QUESTION:

**OPINION:**

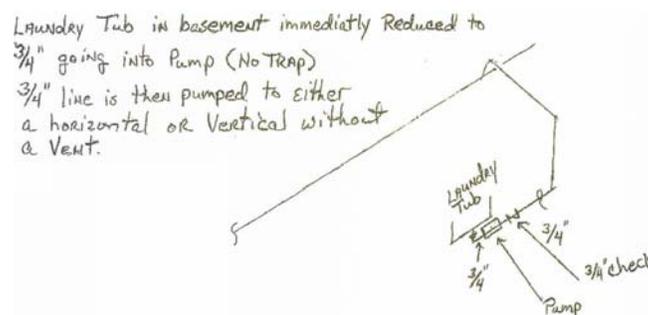
In drawing, we have a laundry tub in the basement which needs to be pumped into the sanitary. I have plumbers that want to use this style of pump. Provided the piping is tied in correctly to the sanitary drain line, does this meet Ohio Plumbing Code without a trap and without a vent?

“By consensus, it is the opinion of this committee that this installation would not be approved. 1002.1 states that each plumbing fixture shall be trapped. 901.2.1 states that every trap and trapped fixture must be vented. Sec. 712.1 states that the min. trap size for laundry tray 1 1/2”
